Outer Door Handles Freeze

R50 (MINI Cooper) and R53 (MINI Cooper S)

Outer door handles in free state.

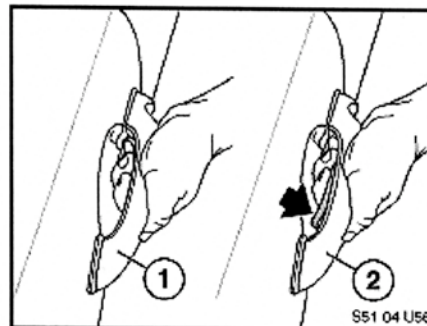
The outer door handles were improved in April 2004. Please see the illustrations below on how to recognize the improved outer door handles.

- 1 - Original outer door handle
- 2 - Improved outer door handle

In the event of a customer complaint, replace both left and right outer door handles with the improved parts by following the Repair Instruction 51 21 170.
